UNITED STATES PATENT AND TRADEMARK OFFICE

APPLICATION NO.	FILING DATE	FIRST NAMED INVENTOR	ATTORNEY DOCKET NO.	CONFIRMATION NO.
09/929,713	08/13/2001	Ed San Mateo	2001 P 11173 US	8925

Office Action Summary

DETAILED ACTION

Figure 7 - U.S. Patent 5, 365, 566 to Maas

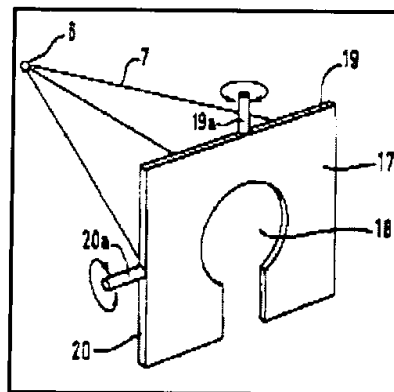
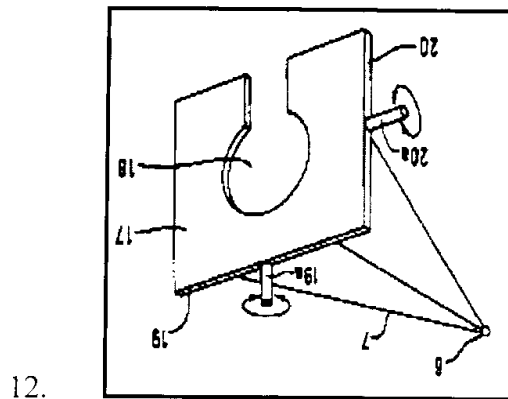
13. Maas discloses an apparatus comprising means arranged on a diaphragm for orientation and beam shaping of radiation (Fig. 7, above, column 1, lines 61-68, column 2, lines 1-2).

17. It would have been obvious to modify the AAPA such that it incorporated first and second connectors; wherein the first coded connector is located along a bottom edge of the tray portion and a second coded connector located along a left edge of the tray portion. One would have been motivated to make such a modification so that the tray could be oriented in a plurality of positions, based on the arrangement of the coded connectors as taught by AAPA (Fig. 2; p. 2, lines 1-19; p6, lines 4-8) and further supported by the teachings of Maas (Fig. 7, above; column 1, lines 61-68, column 2, lines 1-2).
